AIRWORTHINESS ADVICE NOTICE

TYPE AFFECTED: SZD-50-3 Puchacz.

SUBJECT: Miscellaneous airworthiness information.

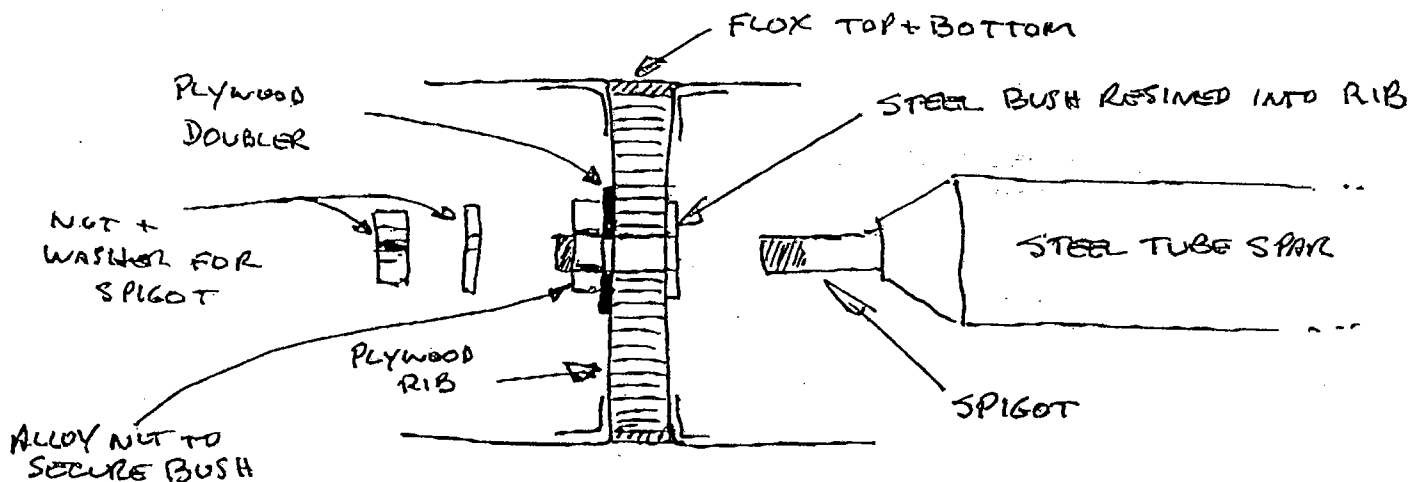
A defect has been discovered in the tailplane of one example of the Puchacz. Details and a sketch of the defect, provided by Tom Gilbert of T and J Sailplanes, are as follows:

The right tailplane half carries the tubular steel main spar, which is captive in the tailplane. A threaded spigot with nut is attached to a plywood rib 310 mm outboard of the root rib. This plywood rib is 8 mm thick and has a plywood circular doubler around the spigot attachment point. A steel bush is permanently fixed (with resin and a nut) in the rib. This is the attachment point for the spigot of the steel tube spar.

During an inspection it was noted that the steel spar in the subject glider could rotate within the tailplane. An inspection hole was cut in the rear shear-web for a boroscope. This showed that the rib was cracked chordwise, but not totally fractured, and the steel bush could rotate in the plywood (resin bond failed). During removal of the rib, broken "flox" was found between the rib and the outer skin.

It appeared that the steel spar had excess load applied span-wise. This may have occurred in a trailering accident some two years previously. The load cracked the rib and caused the resin bond with the bush to fail. This in turn allowed the main spar to rotate. The spar has to be in its correct rotational position for the locking pin to locate.

The rib was replaced, which required large access holes to be cut in top and bottom skins, together with some simple jiggling.

Recommendation. It is recommended that the tailplane be removed from the aircraft as soon as practicable and a check made that the tubular spar is secure in the RH half, i.e. that it cannot rotate. **Caution:** do not use excessive force when checking for rotation, or a problem could be caused which did not exist before. If a genuine problem does exist, it will be detected by applying a relatively light rotational force.
